Kennecott Utah Copper, LLC
Large Bingham Reservoir System
GROUND WATER DISCHARGE PERMIT UGW350006
Renewal
Comment Response Summary
Division of Water Quality
April 2021

A. Kennecott Utah Copper, LLC Large Bingham Reservoir System

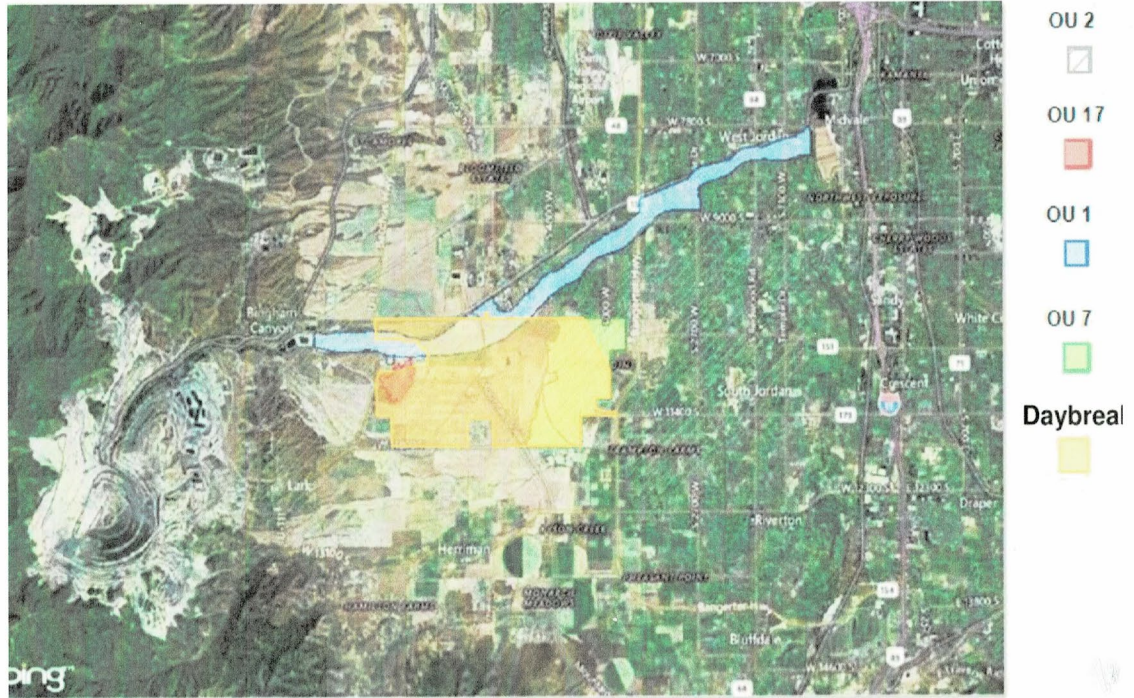
We must assume that the catalog of scientific literature of eco-toxic effects of selenium is widely available, at least as available as it was to Kennecott's decision makers in the late 1990s, when literally millions of dollars of funding was spent in the building of the "biosulfide plant", pictured below in its early months, one primary purpose of which was to reduce selenium selectively for removal of selenium contamination from acidic leach waters gathered from the eastside collection system and aquifers, upgradient and downgradient, of the Large Bingham Reservoir vicinity:

This pioneering Biosulfide plant worked, and worked wonderfully, according to the process engineers-operators and their reports. It was possible to extract selenium --- as well as a catalog of other metals --- by selective chemical reduction. Where does that process stand in the intentions of the present ground water discharge permit? One way or the other, Kennecott/Rio Tinto have long since admitted that selenium is a constituent of acidic leach waters, both from the north Refinery area and from the leaching of the vast Waste Rock Dumps and Concentrator area. The academic work of Dr. Wayne Wurtzbaugh and colleagues at Utah State University have categorically identified the critical, negative effects of Selenium on the Great Salt Lake.

The objective of the Large Bingham Reservoir System Ground Water Discharge Permit UGW350006 is to monitor the reservoir system for leaks. As described in Part I.B.1 of the permit, BAT discharge control design elements of the reservoir liner include (bottom to top) a 1-ft thick

clay layer with hydraulic conductivity no greater than 1×10^{-6} , a layer of geotextile material, a secondary (lower) 60-mil HDPE liner, another layer of geotextile material, and a primary (upper) 80-mil HDPE liner. The area between the primary and secondary HDPE liners is divided into 10 individual sumps that act as a leak collection system and narrow the area of maintenance and repair if a leak is detected. As such, monitoring and inspection requirements under this permit are limited to the performance and integrity of the liners. Ground water treatment or monitoring activities do not fall under the scope of UGW350006.

(Daybreak Development Rel. to Mine Terrain; Daybreak Site in Yellow)

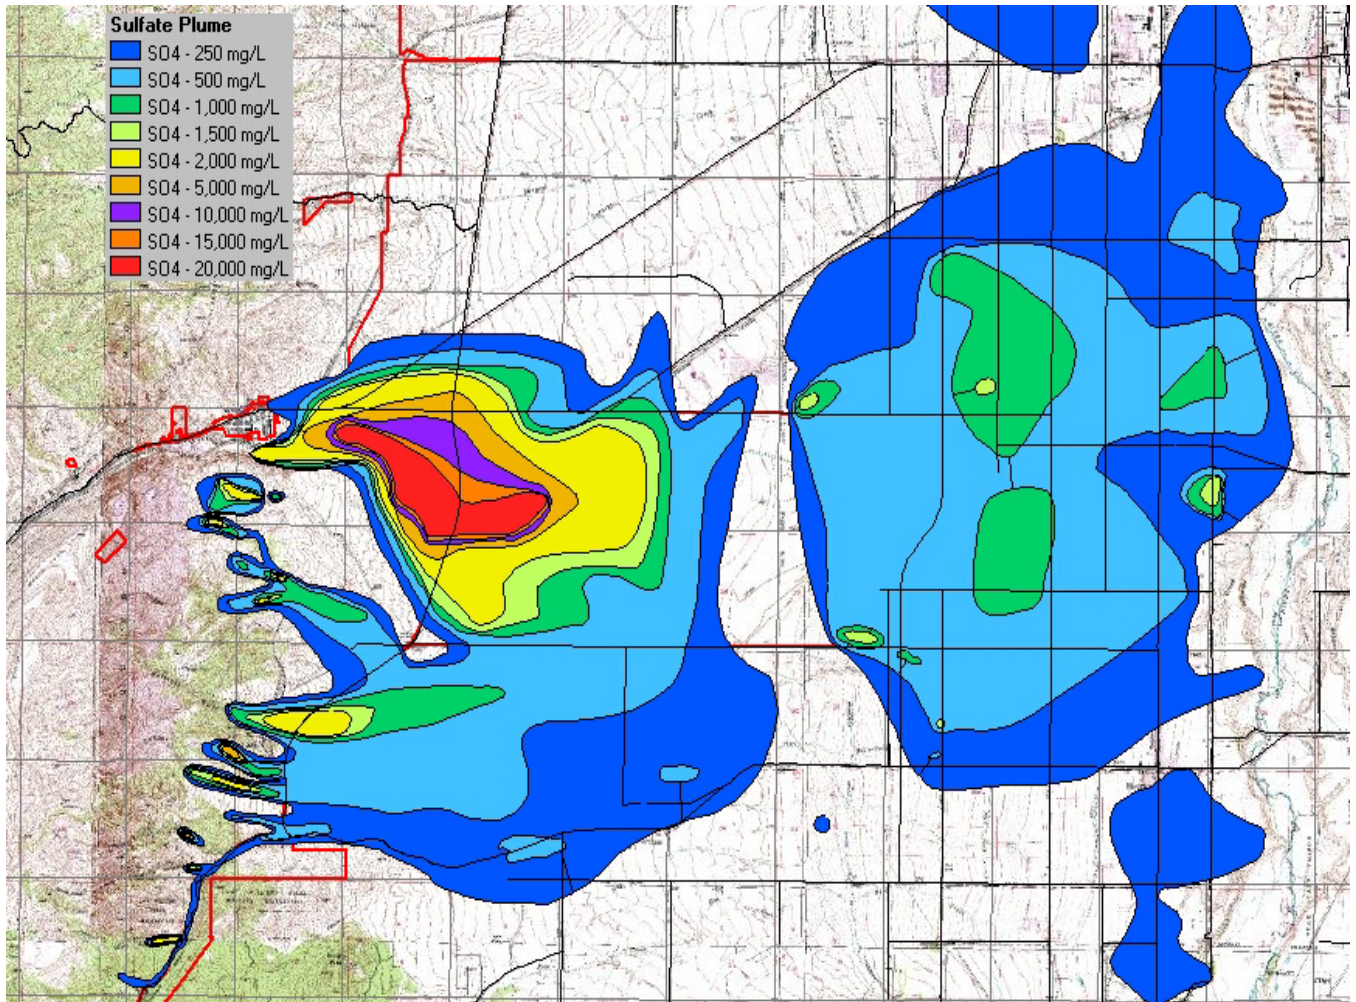
And then there's Daybreak, growing at a terrific rate immediately below Highway 111 --- and above, very near the Bingham Mine waste rock dumps, where acid rock drainage is generated --- and planned even to engulf the Large Bingham reservoir on its north and south flanks, near the historic mining town of Lark. Soil and ground water assume a similar geochemical identity, as ground water emerges to or near the surface. Considering that the soil cover standards for Daybreak call for a minimum of 18", it becomes obvious that there's not a great deal of earth separating residents from soils and waters that have been cleaned or diluted to some relatively uncertain degree.

The following series of images approaches an accurate perspective on Daybreak's environmental 'place' relative to historic Kennecott mining operations:

S. Jordan Evaporation Ponds prior to Cleanup / Reclamation (looking westward over the Daybreak site):

The concerns captured in the images and narrative above do not fall under UGW350006 (described in comment response 2). As listed in comment response 1, the DWQ regulates Kennecott operations and facilities via multiple permits specific to a given activity or location. Specifically, the cutoff walls are regulated under UGW350010 (Bingham Mine Leach Collection System), the tailings pipeline is regulated under UGW350017 (Copperton Concentrator), the tailings impoundment is regulated under UGW350011 (Tailings Impoundment), and discharge points at the shores of the Great Salt Lake are addressed under UPDES Permit UT0000051 (Surface Water and Storm Water Discharges).

Sulfide Ground Water Plumes below Large Bingham Reservoir, Eastside Collection System, and Lands to East of Daybreak Site. Bingham Mine is to the left, north toward top:

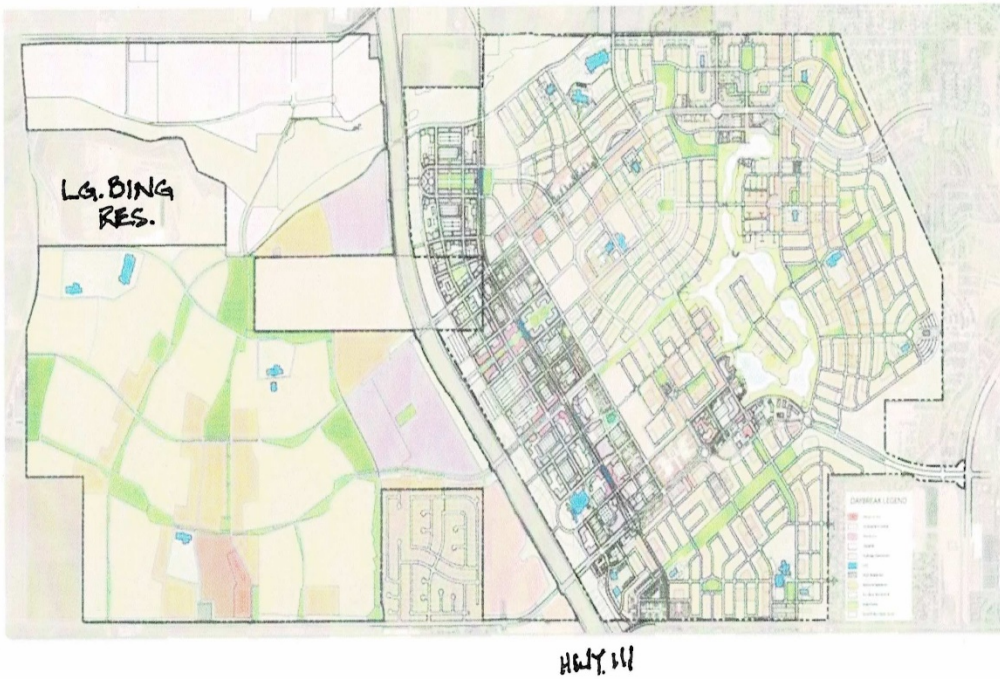
In Summary: “Site” must be understood in its full extent, from the southernmost cutoff/interception wall in Yosemite Drainage (or wherever it is, in this day and age of climate change), through the entire sequence of cutoff walls and piping, through the Desilting Basin and both zones of the Large Bingham Reservoir, and also through the pipeline to the discharge points at the shores of the Great Salt Lake. Delineation of the site to its full extent is fundamental to an ecologically responsible basis for administering Permit 350006 to fully honor community environmental justice principles into the future!

The sulfide plume shown in the above figure is undergoing monitoring and remediation under an EPA Record of Decision and is not managed under DWQ authority. Likewise, soil cleanup

activities within the area now occupied by Daybreak were conducted under Federal (EPA) regulation and do not fall under DWQ permits.
